Re: Edgewater proposal

To: Plan Commission Members
From: Peter Ostlind
Re: Edgewater Redevelopment Proposal
Date: February 4, 2010

Commentary on Edgewater UDC 1/20/10 and 2/3/10 Submissions and Handout

Subject: Edgewater Hotel Redevelopment

Existing Green Space @ 1" = 40'
 The Edgewater Reconsidered
 December 2, 2009

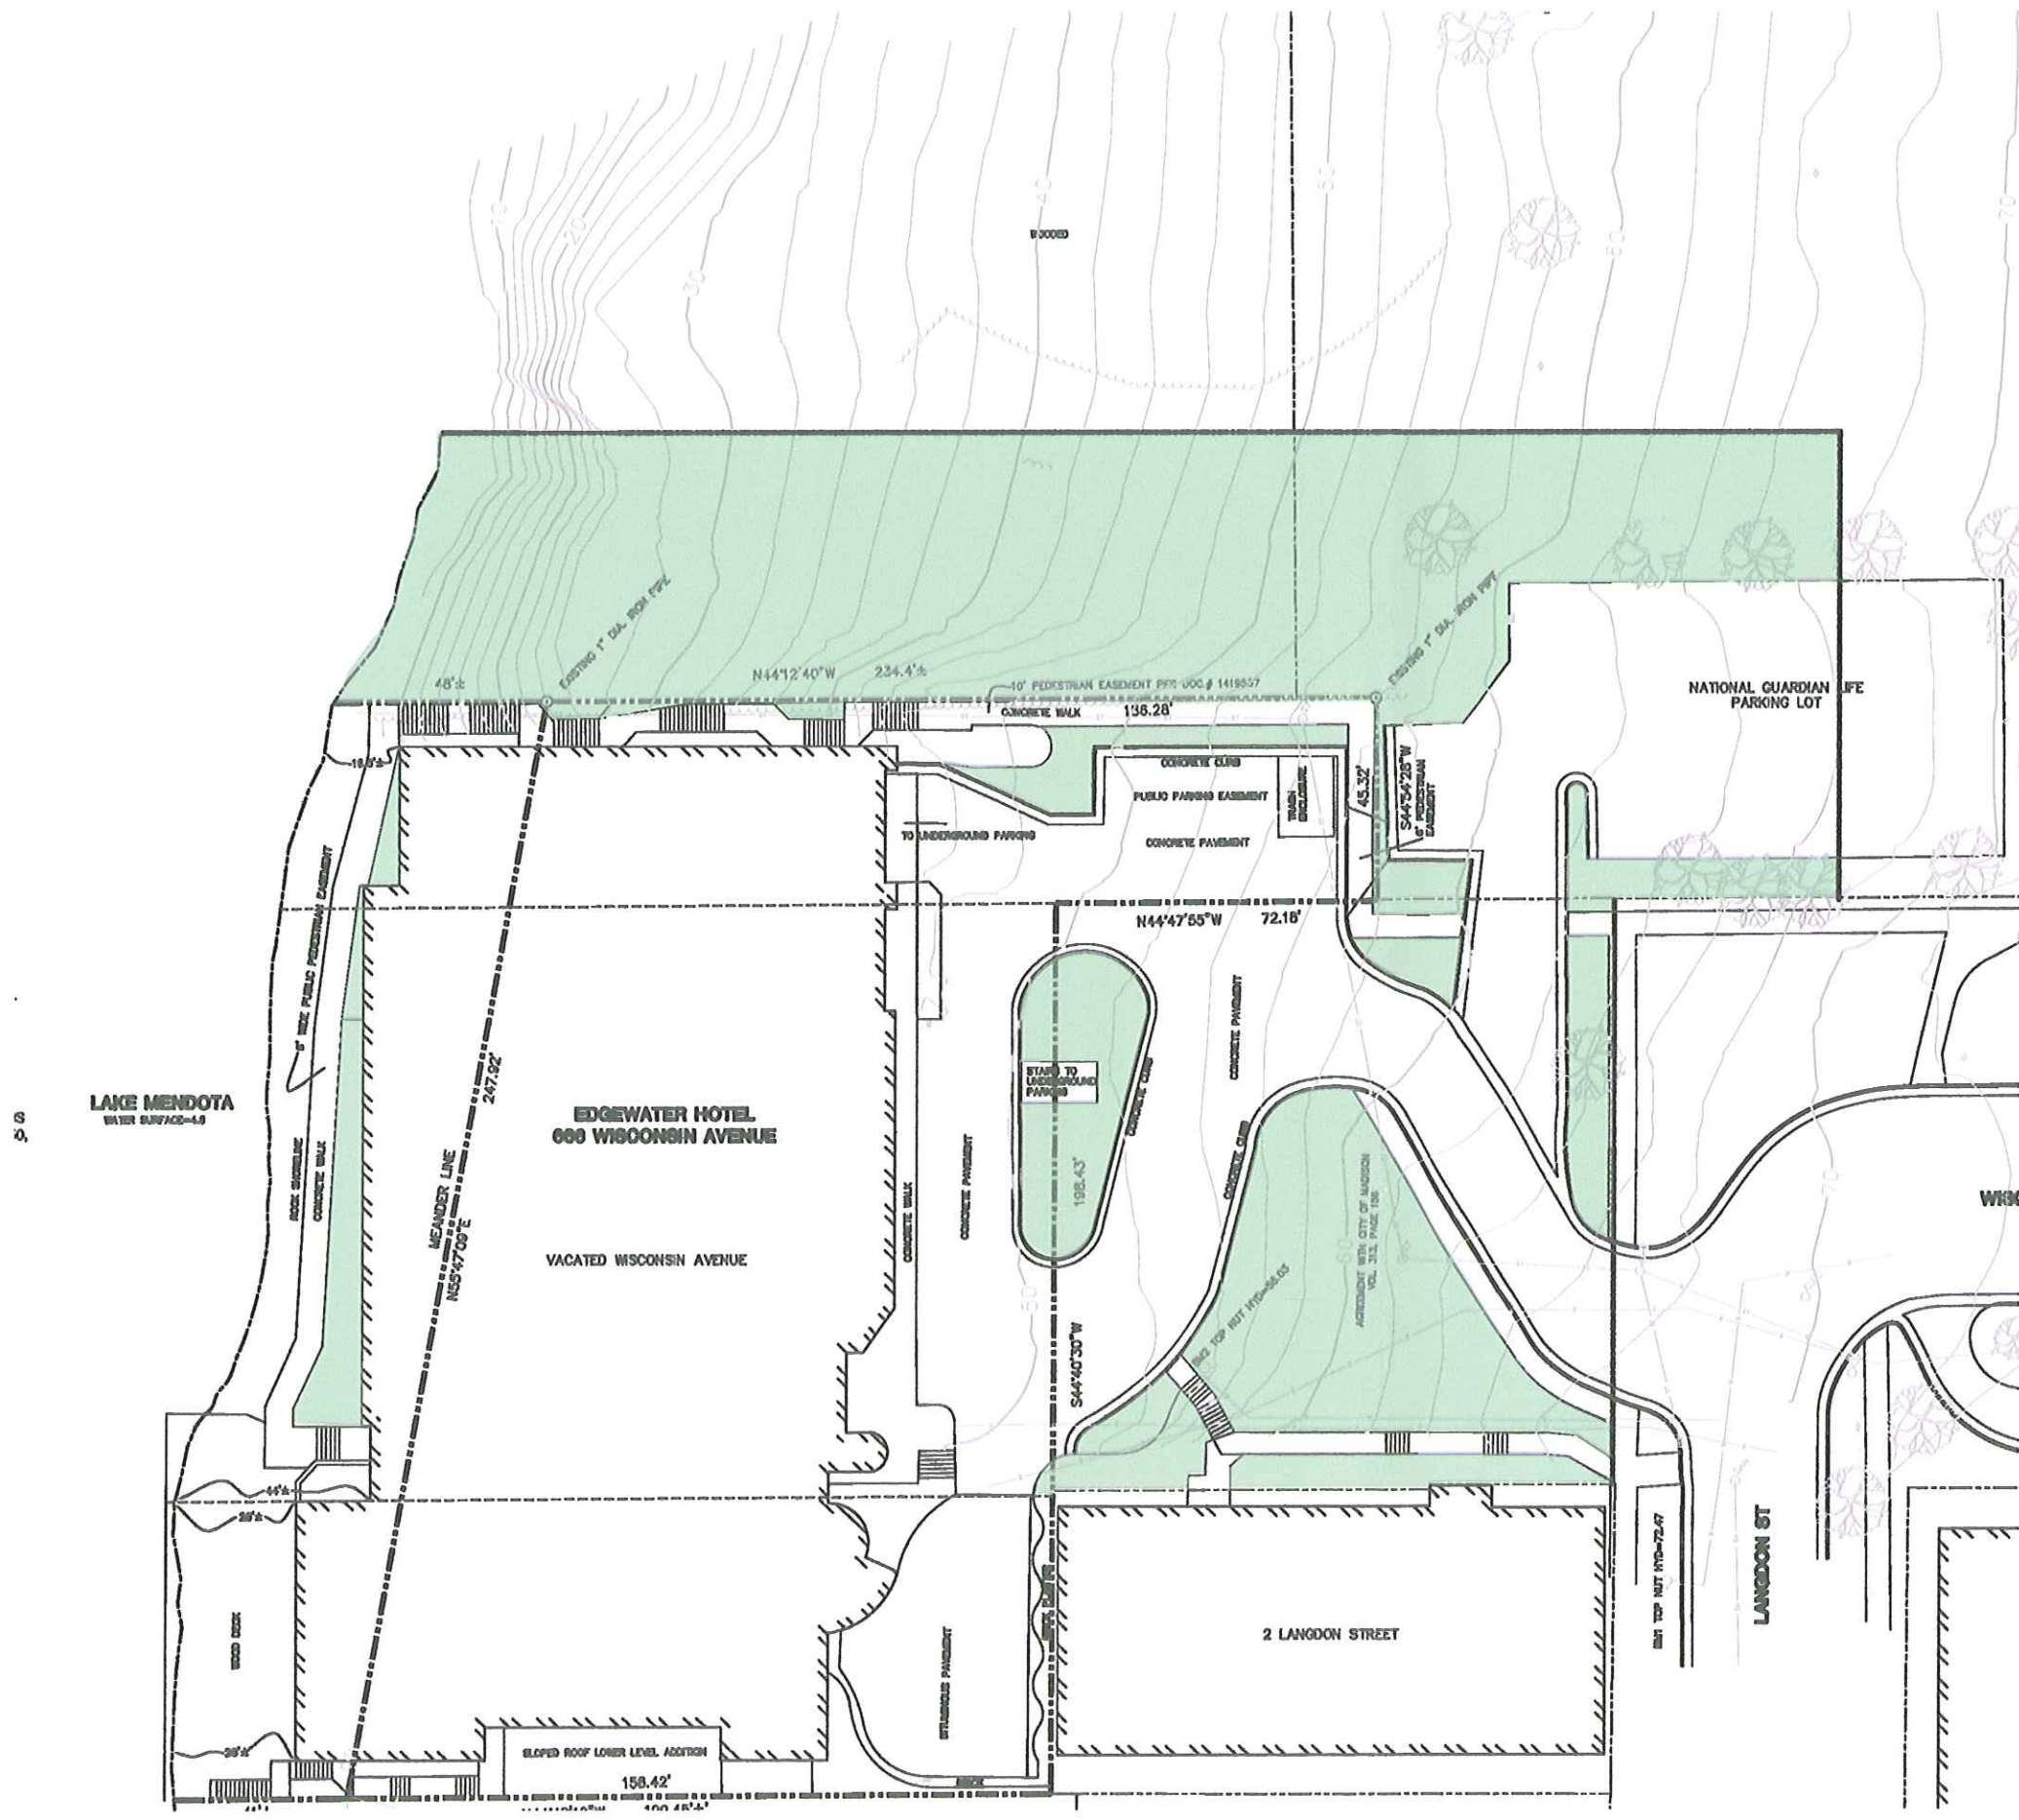
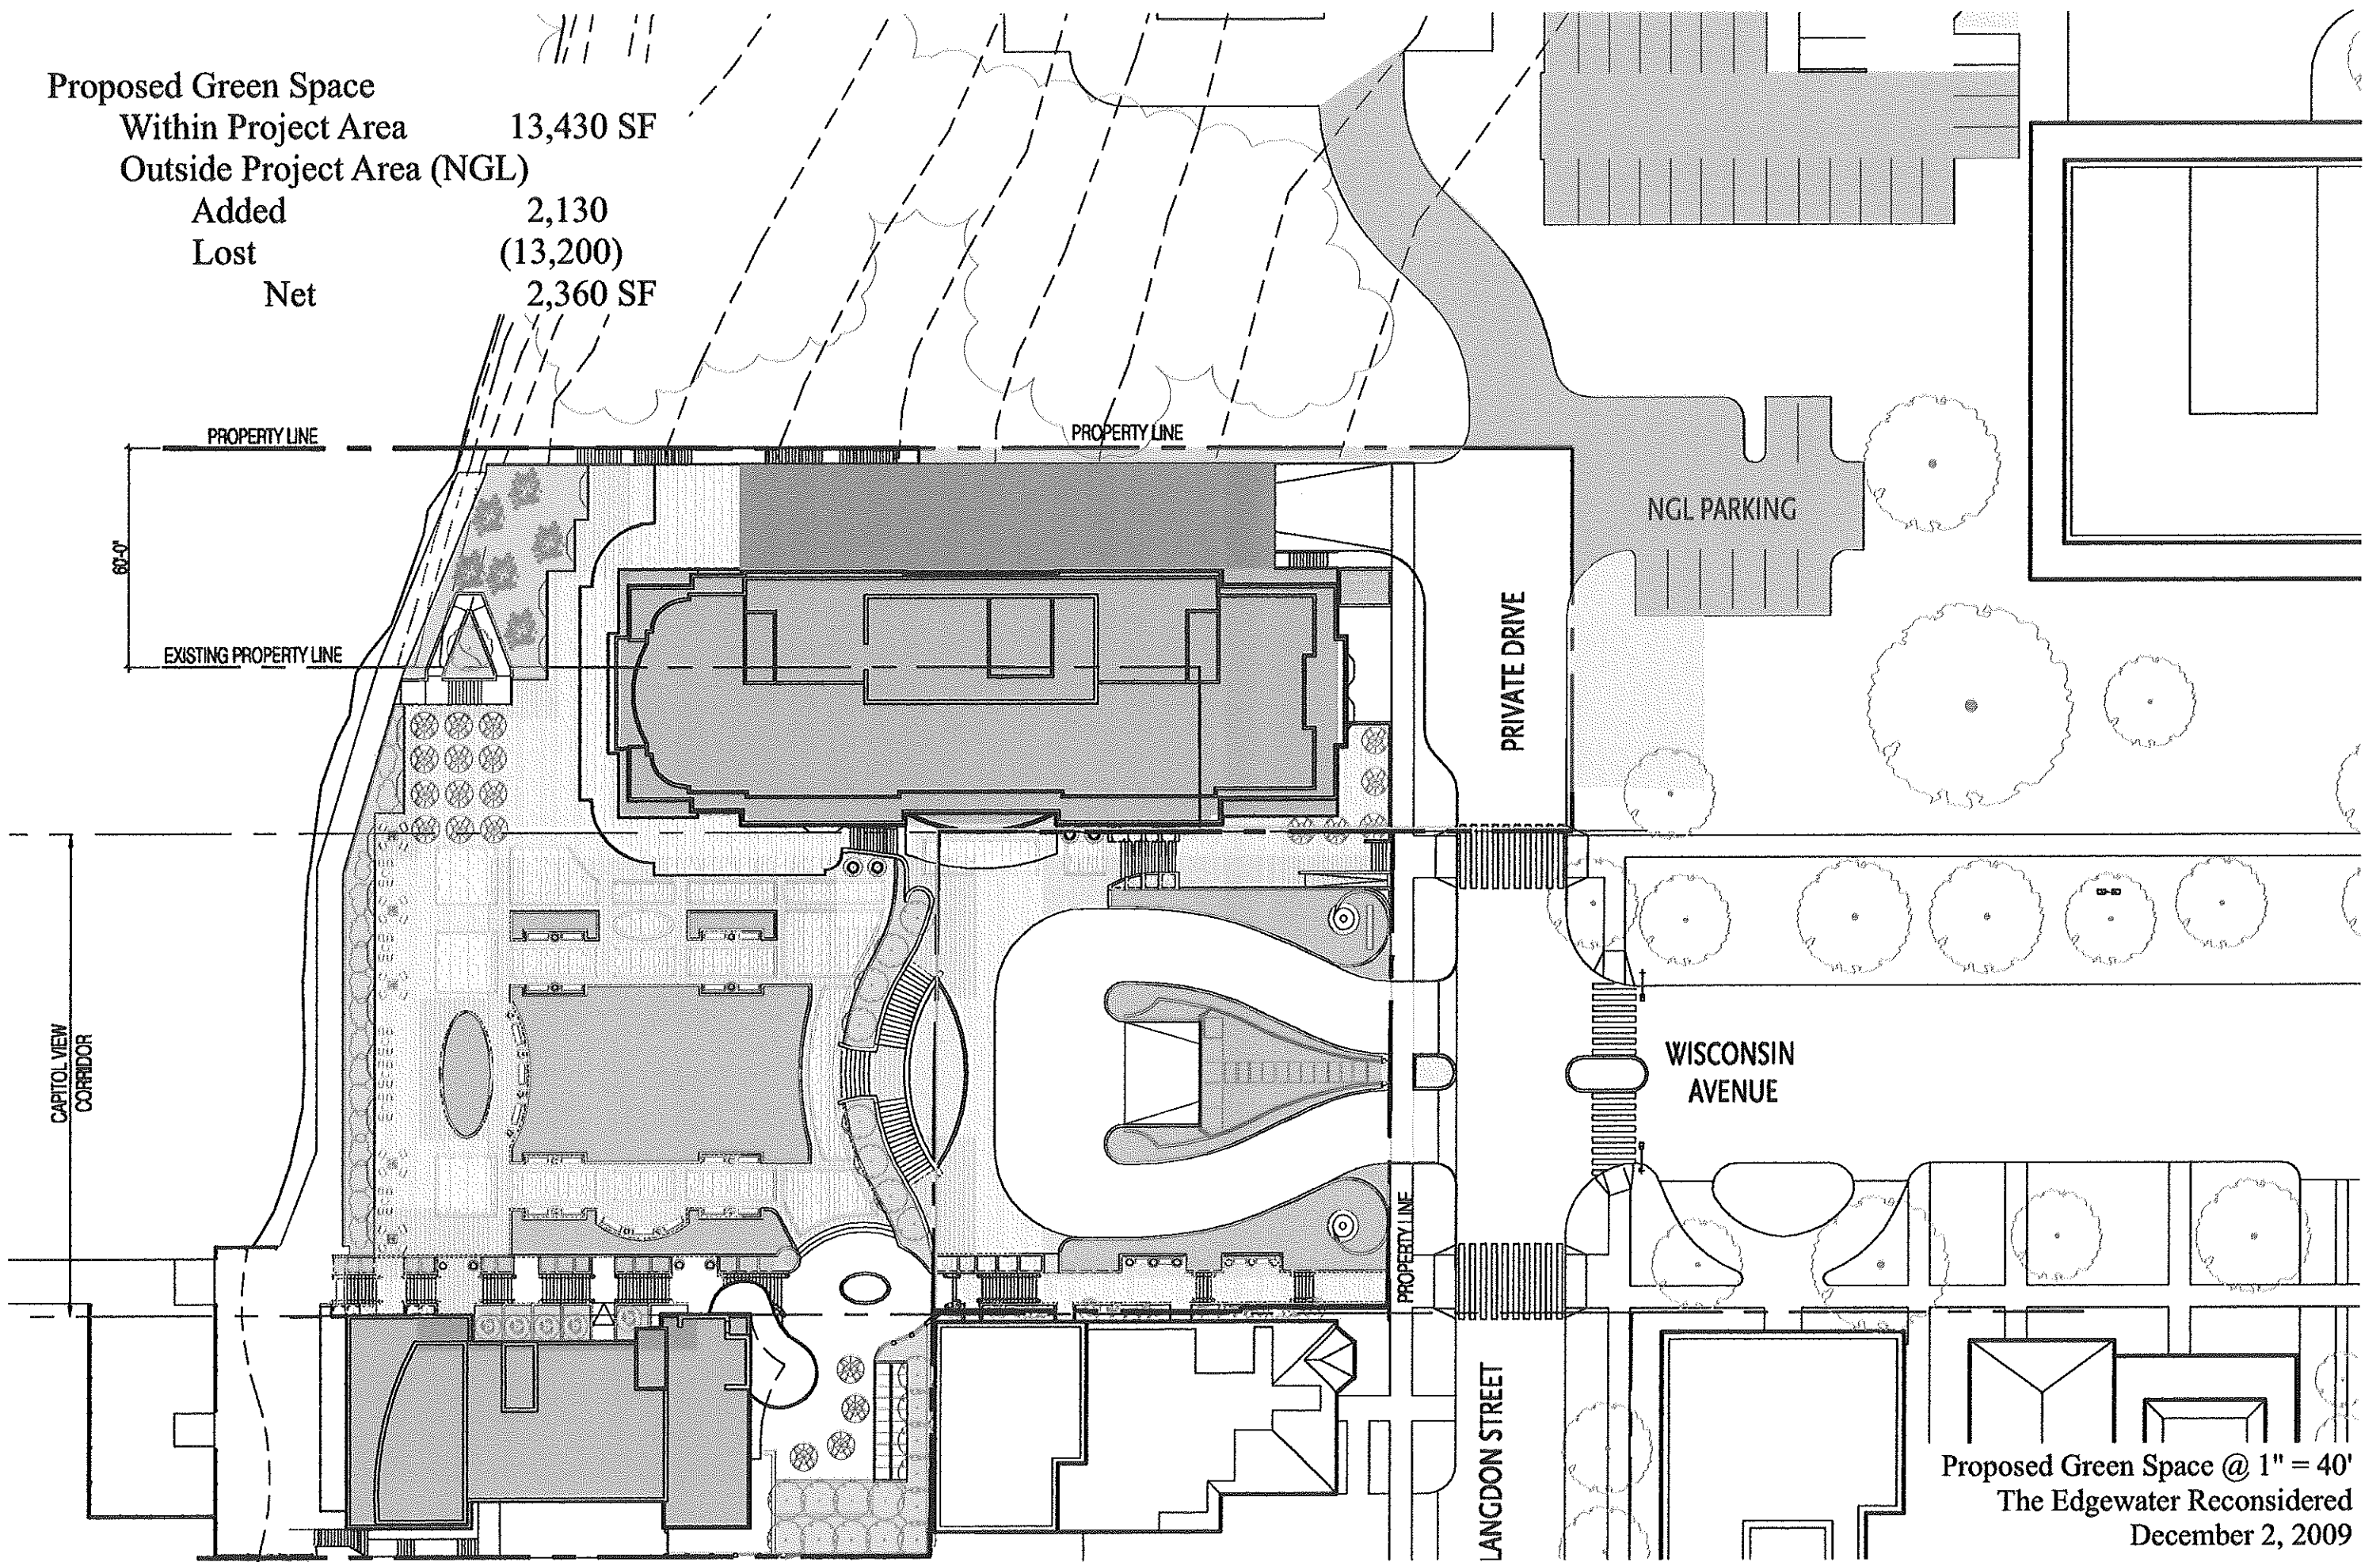
Green Space - Existing: 27,320 SF
 Green Space - Proposed: 2,360
 Green Space Lost: 24,960 SF

Proposed Green Space
 Within Project Area 13,430 SF
 Outside Project Area (NGL) 2,130
 Added
 Lost (13,200)
 Net 2,360 SF
